ADDENDUM 2

Project: Tanners Creek Manor

Addendum Issue Date: July 22, 2026

F1-6
07/06/2026

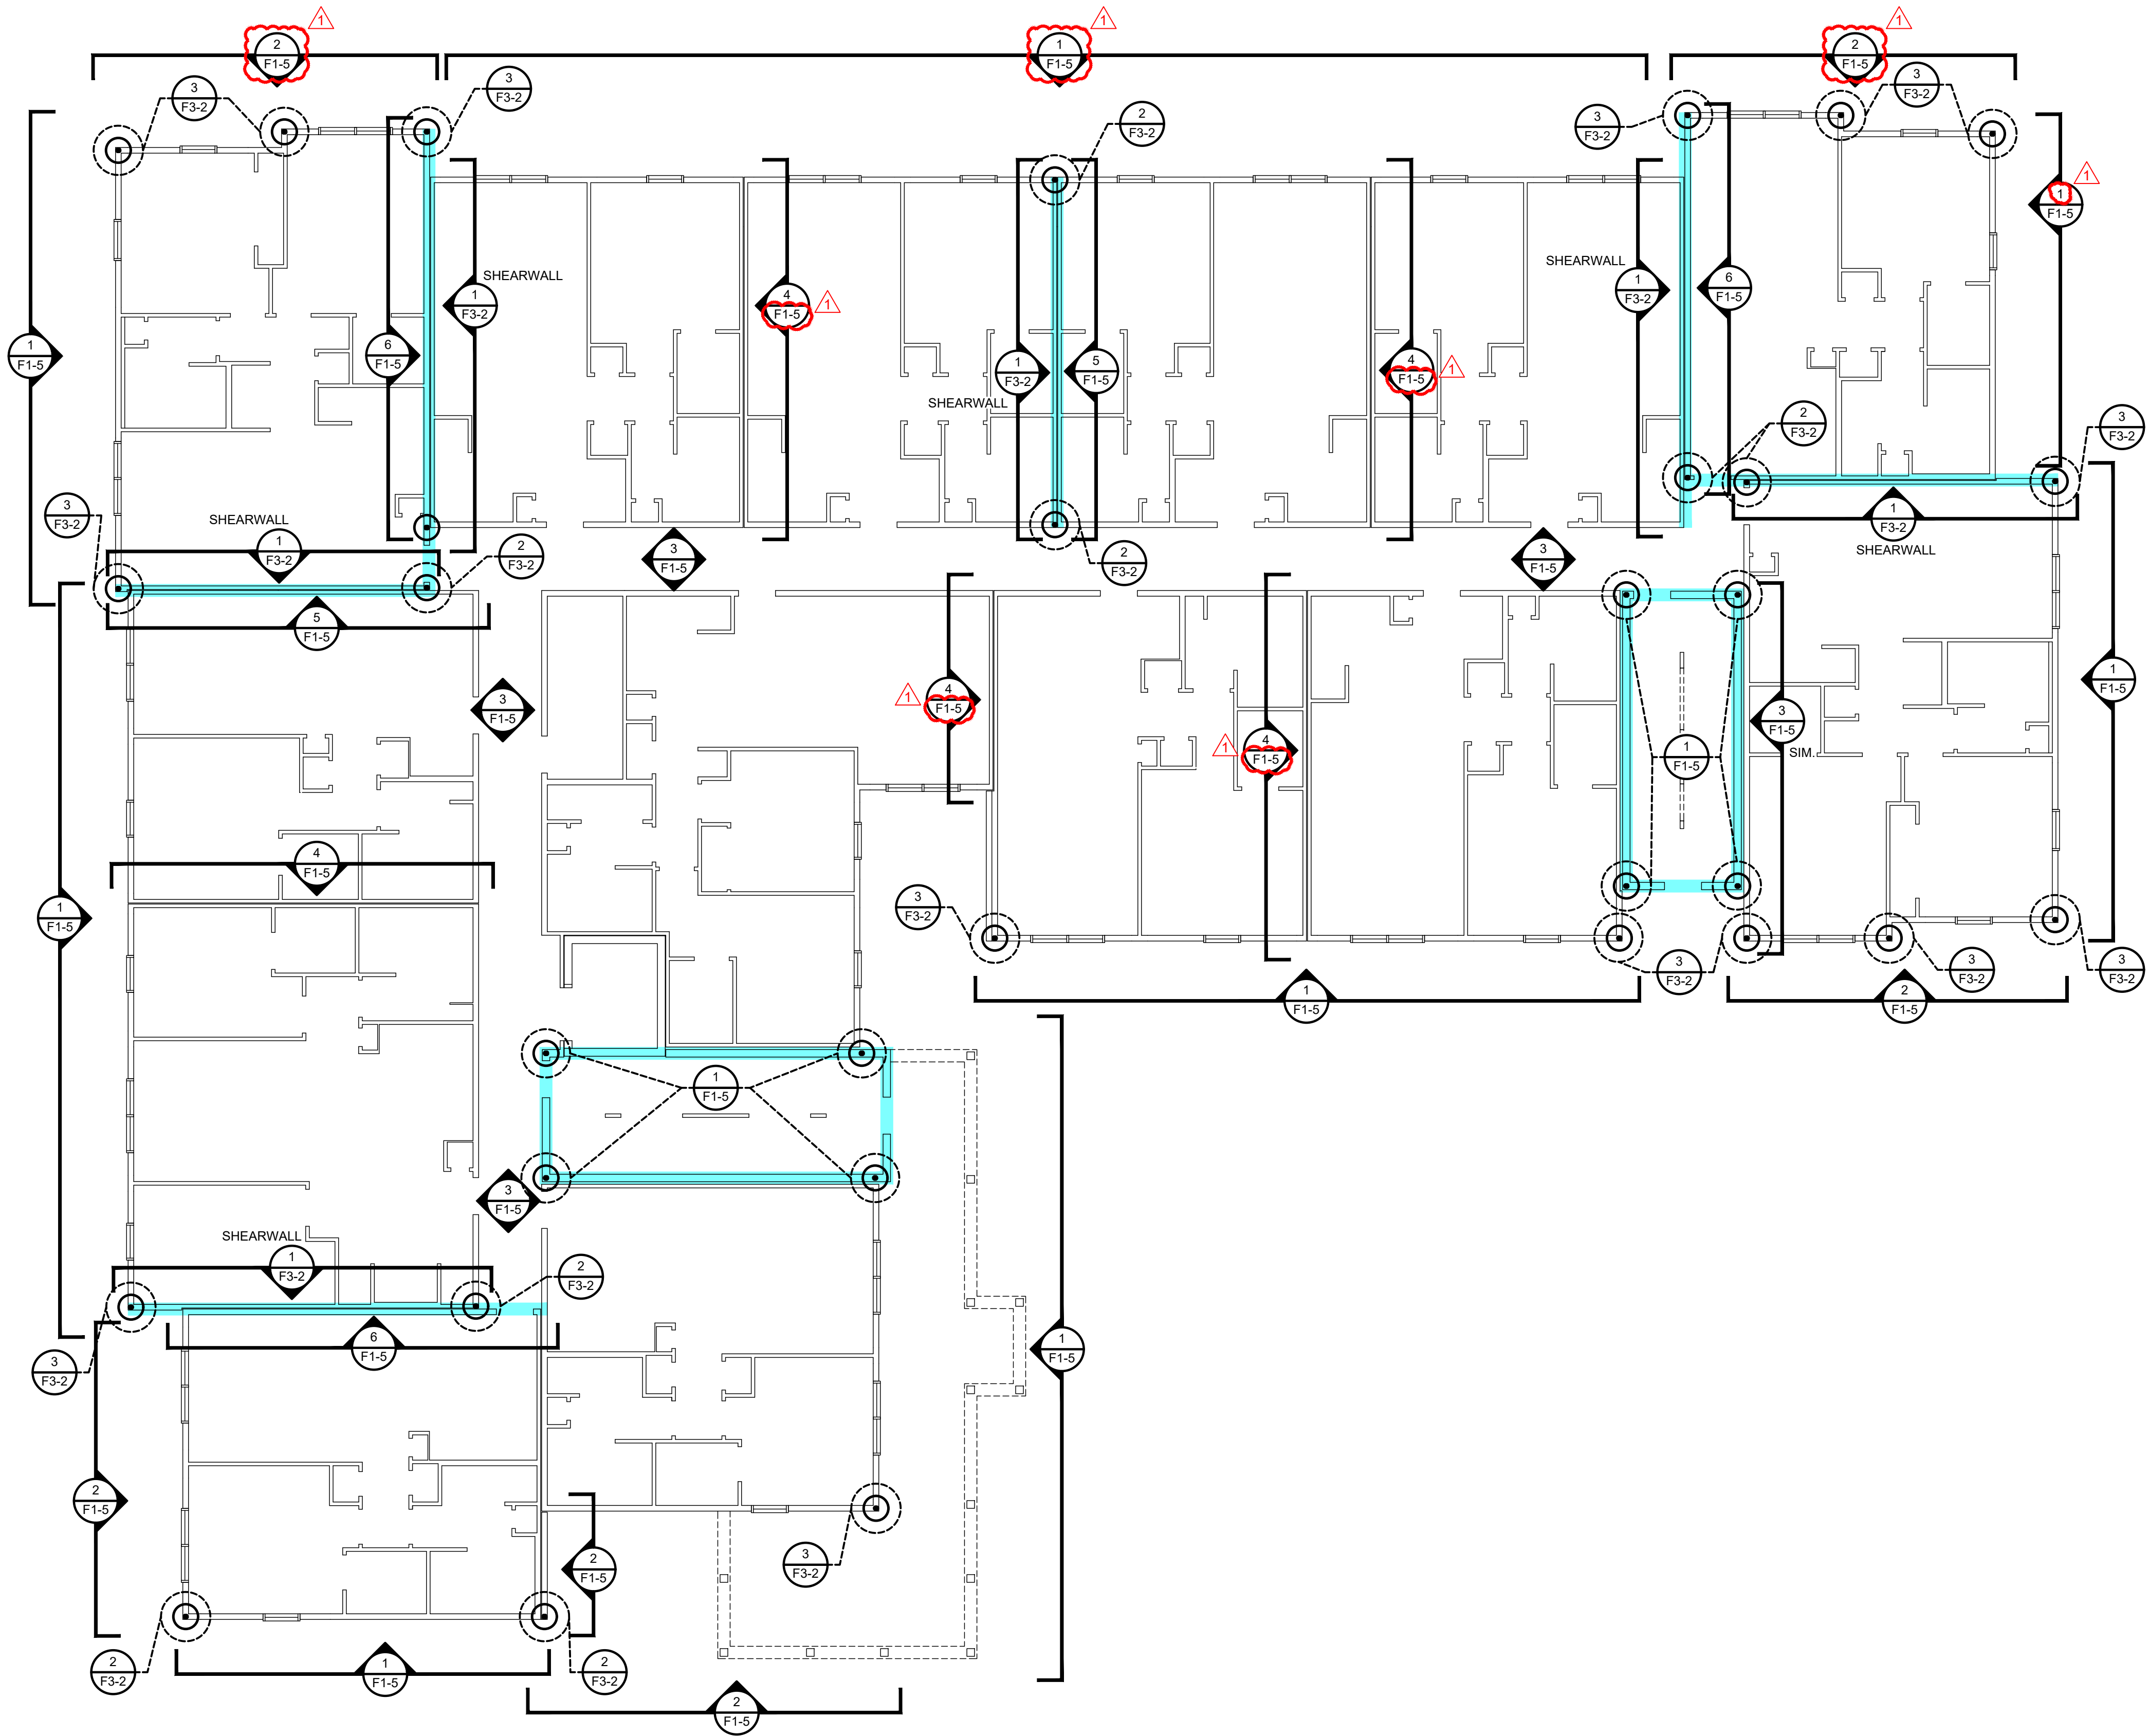
CORRECTED
WALL FRAMING
CALL OUTS

F1-7
07/06/2026

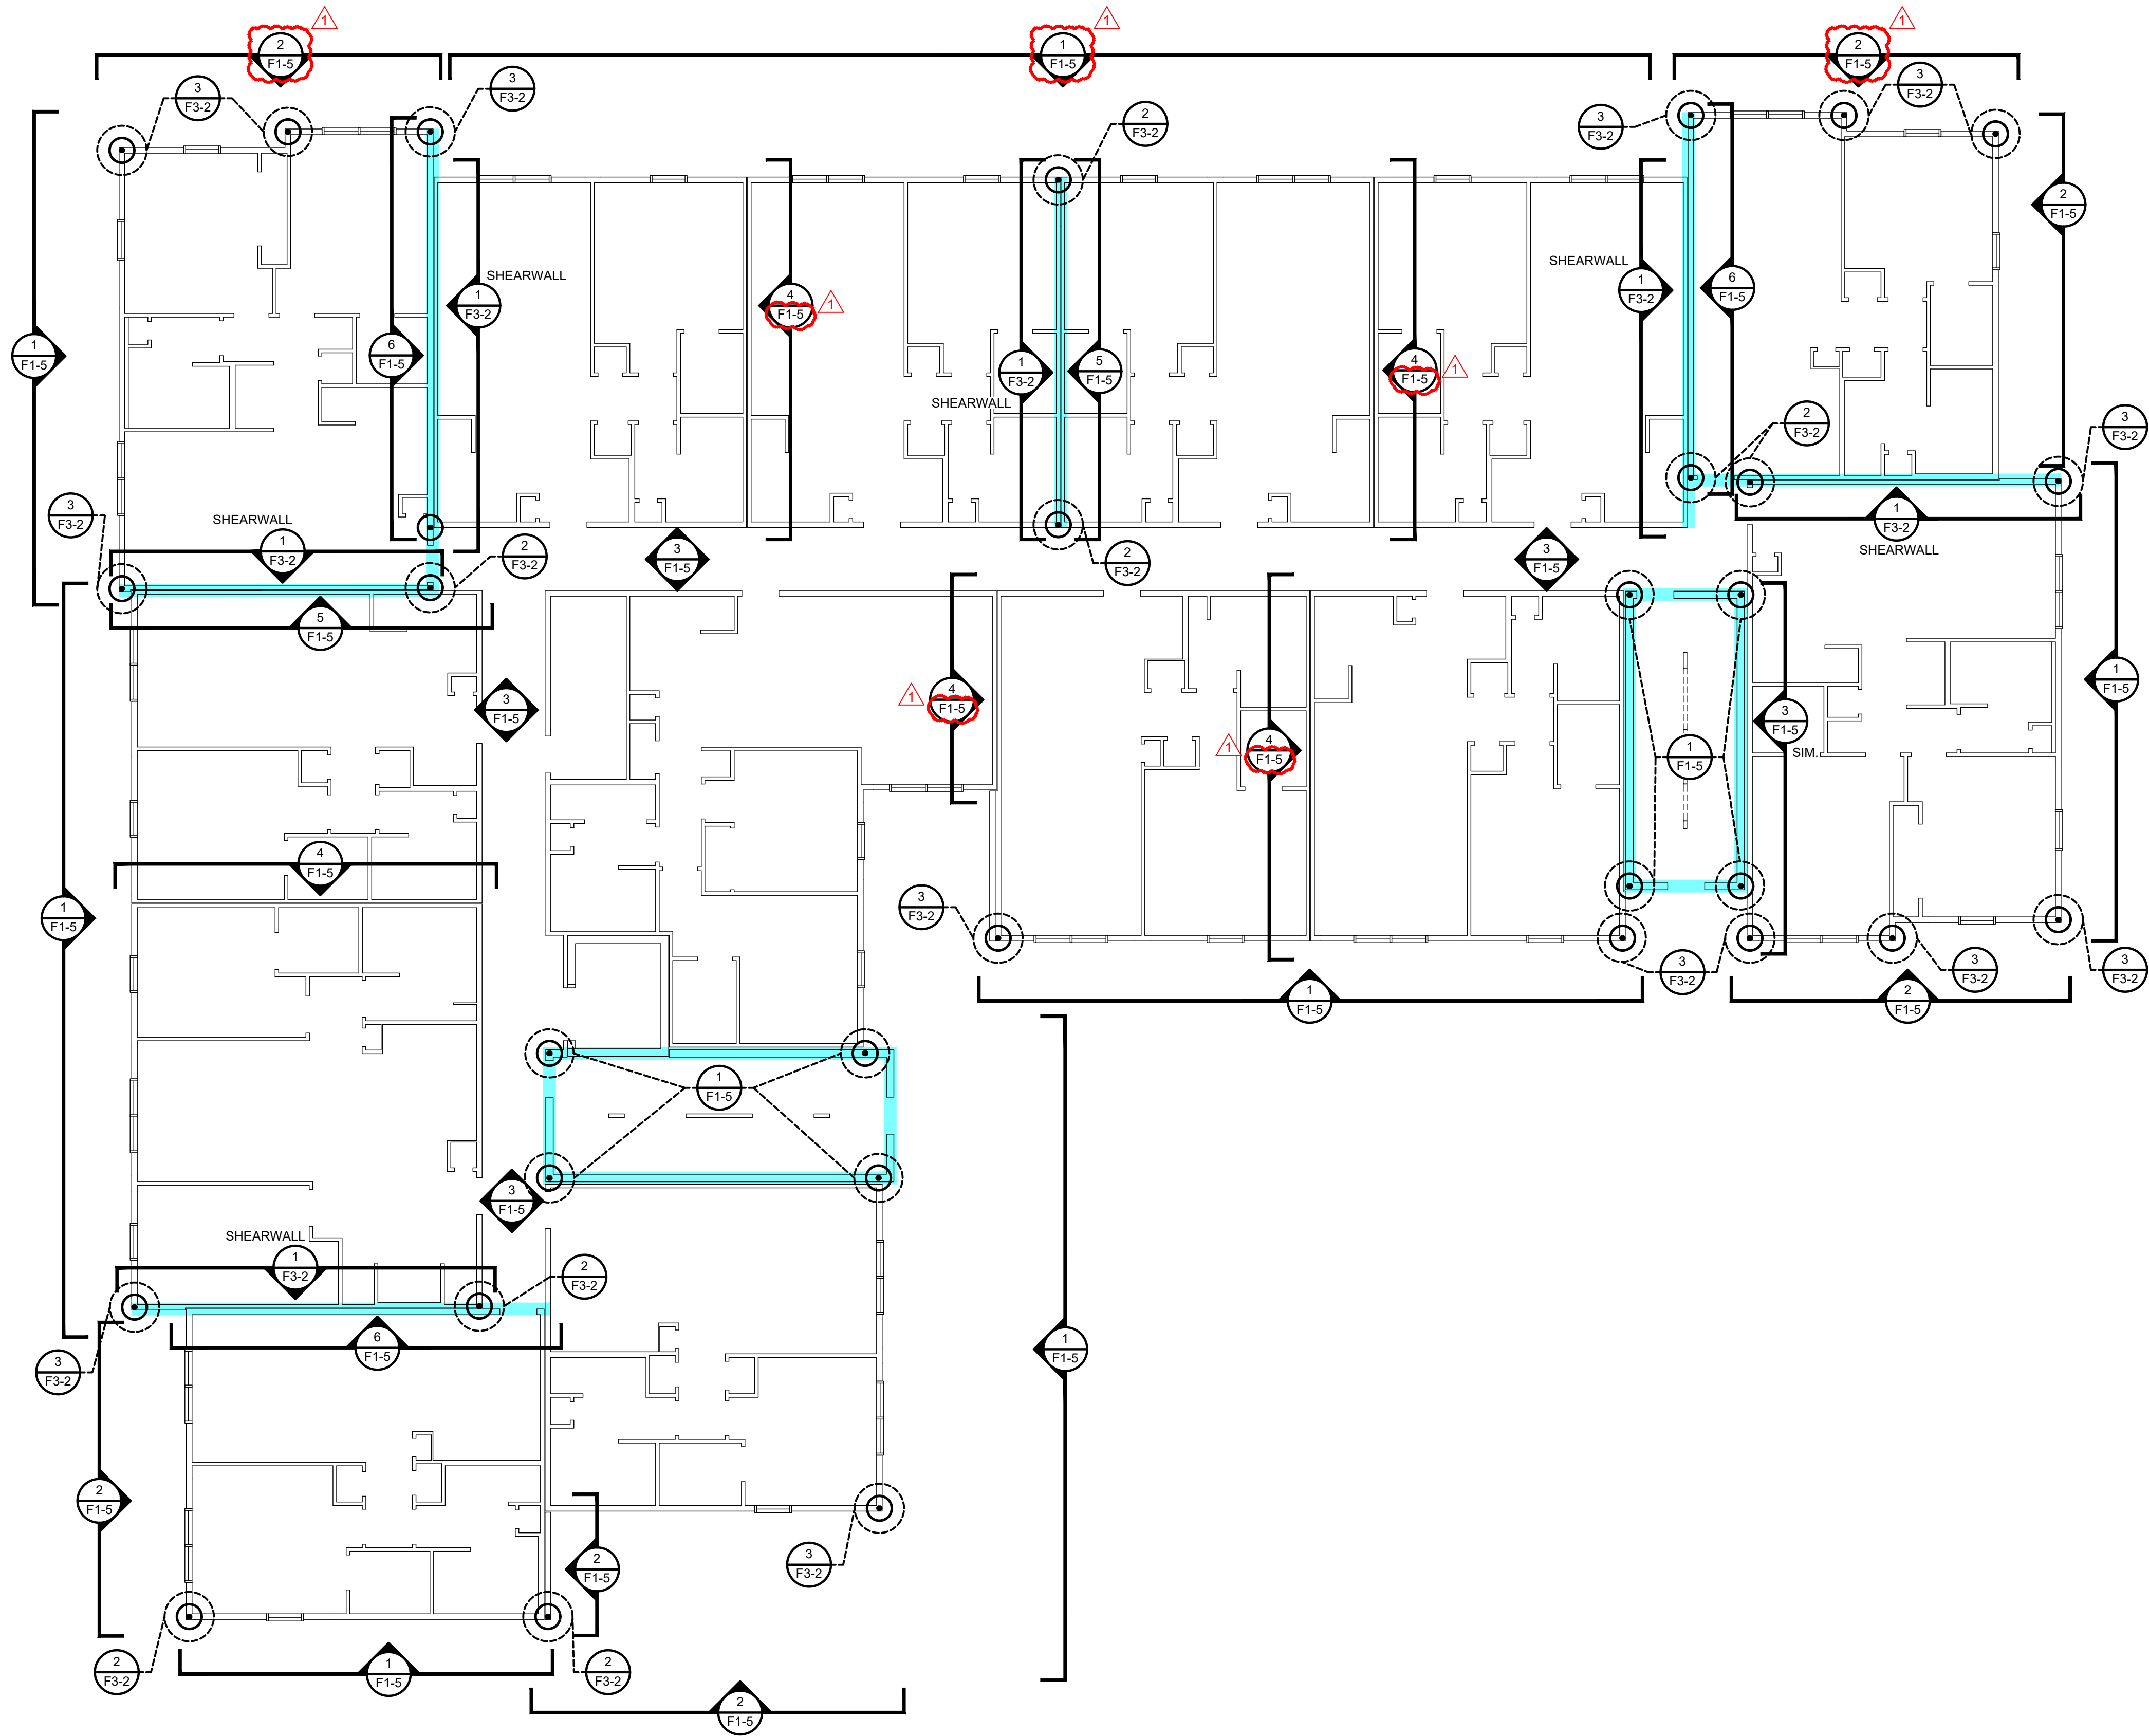
CORRECTED
WALL FRAMING
CALL OUTS

F1-8
07/06/2026

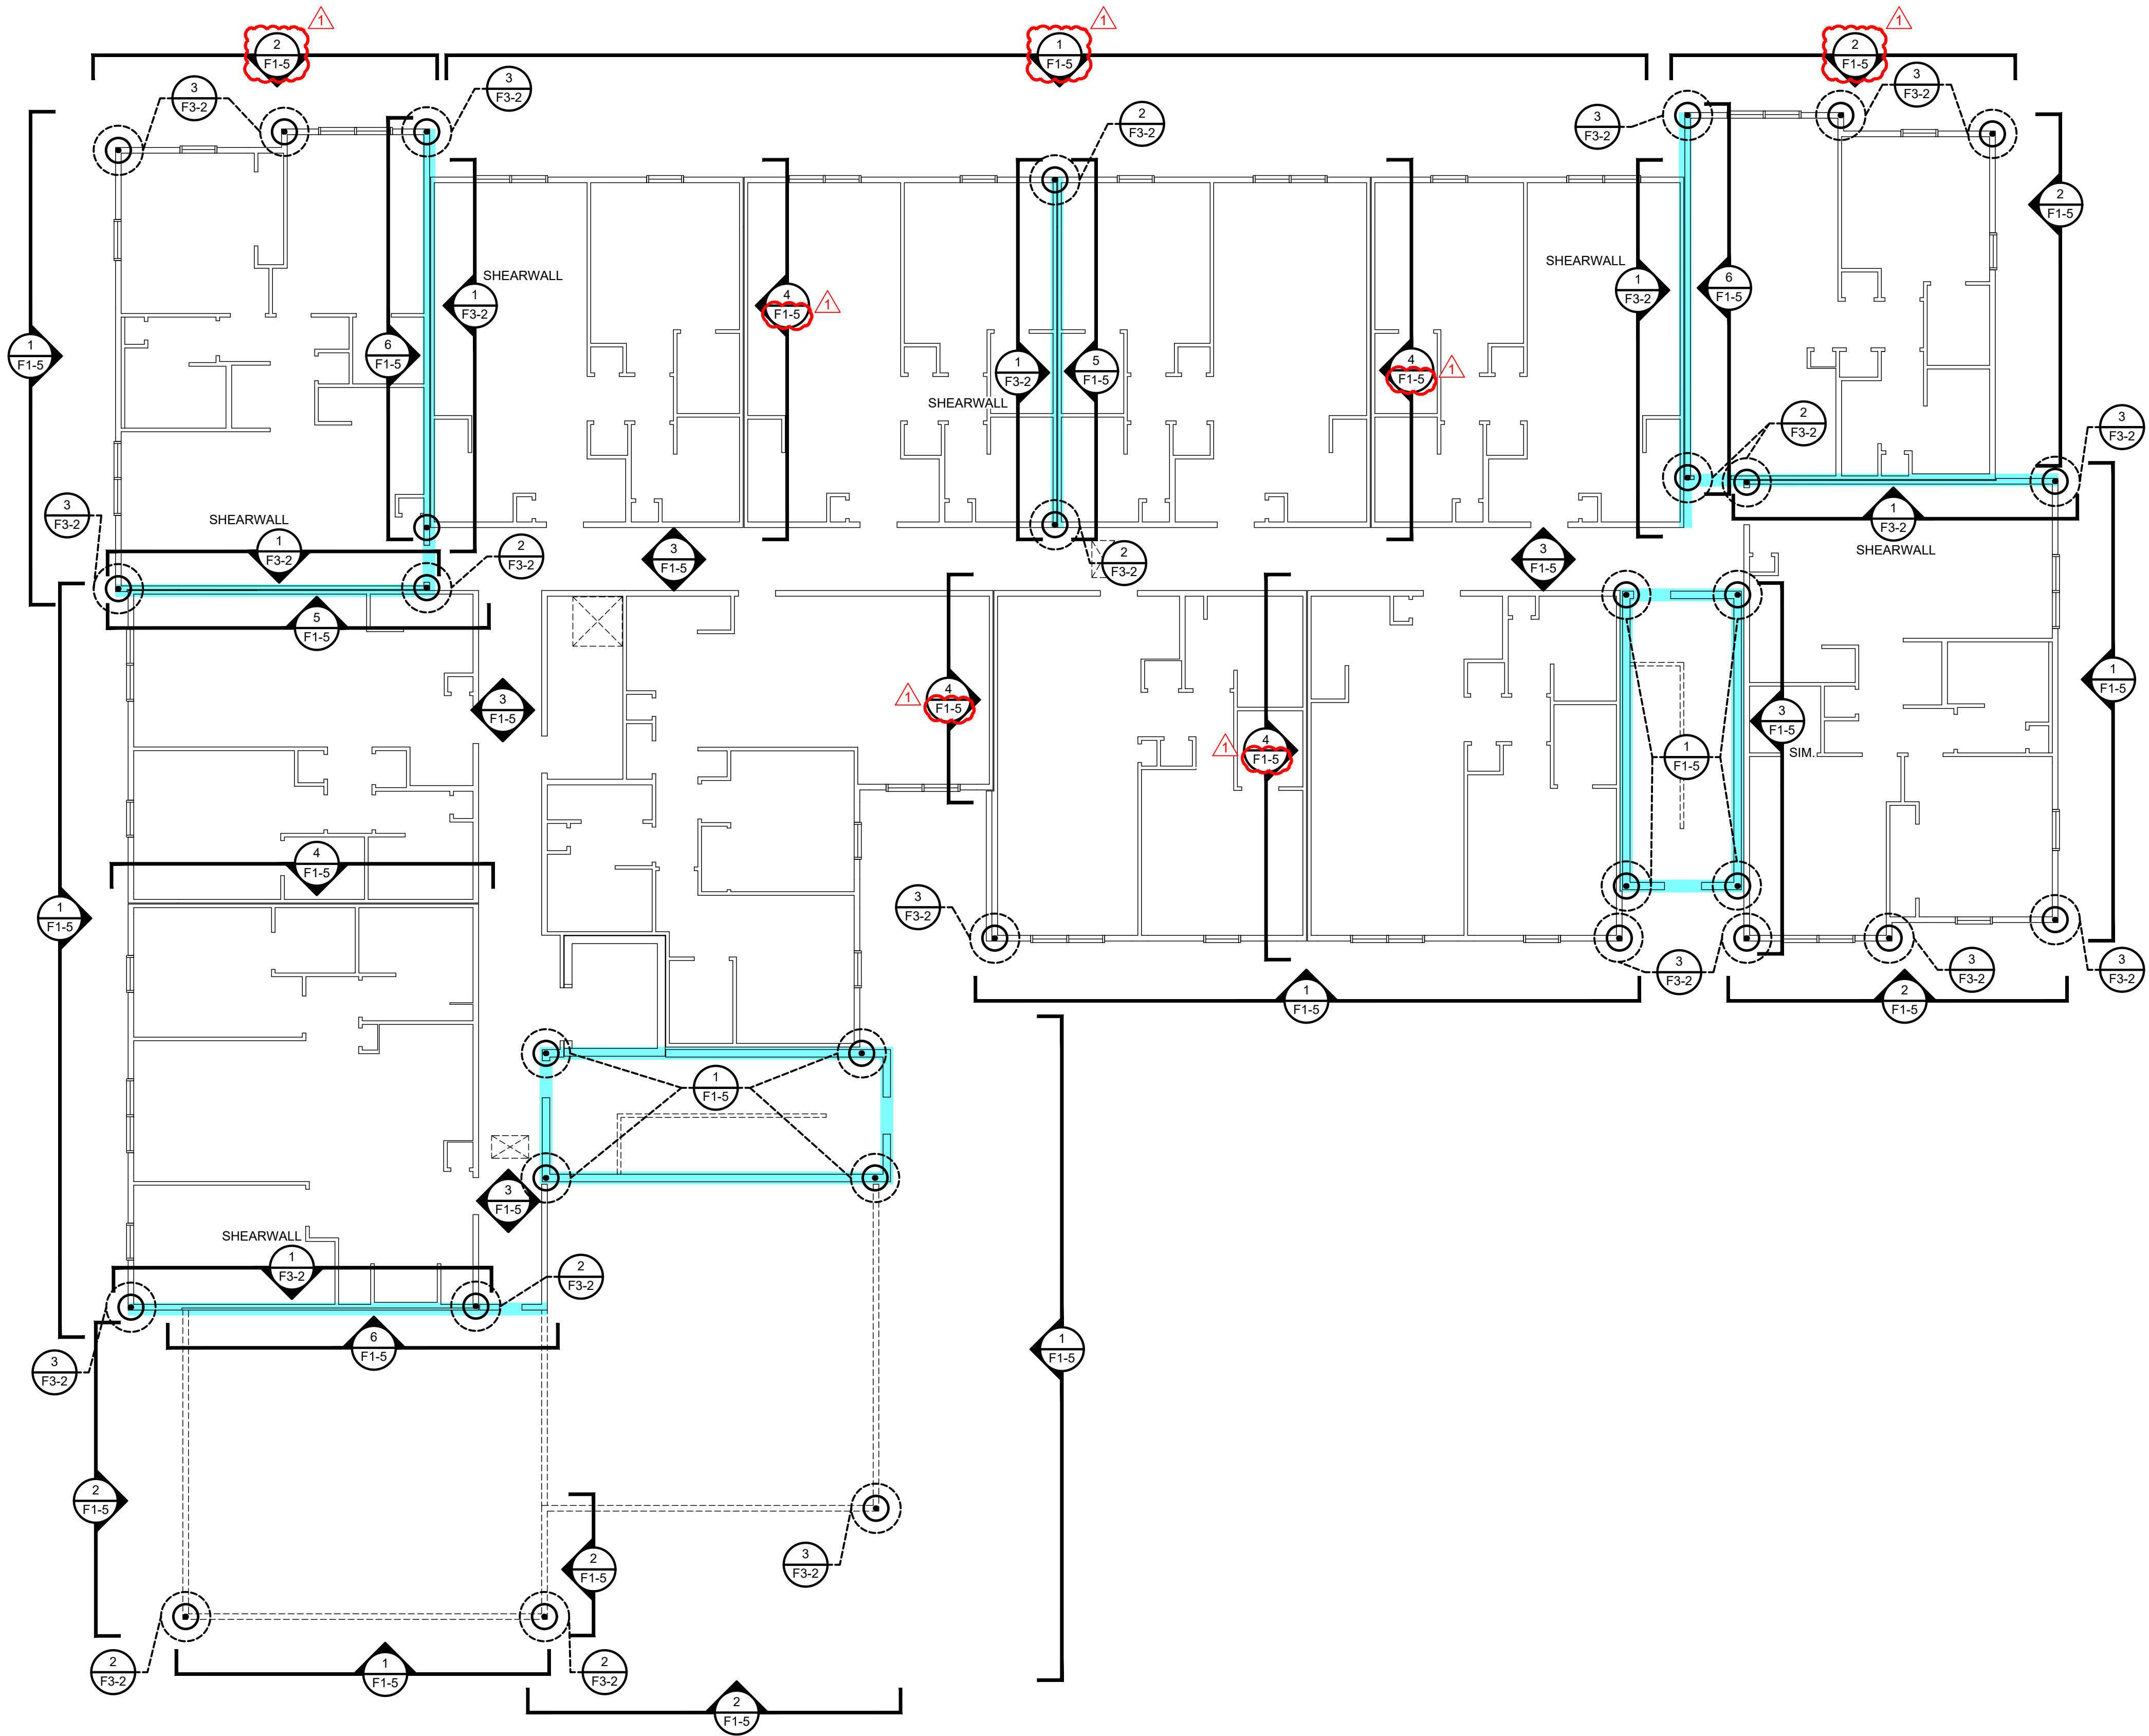
CORRECTED
WALL FRAMING
CALL OUTS
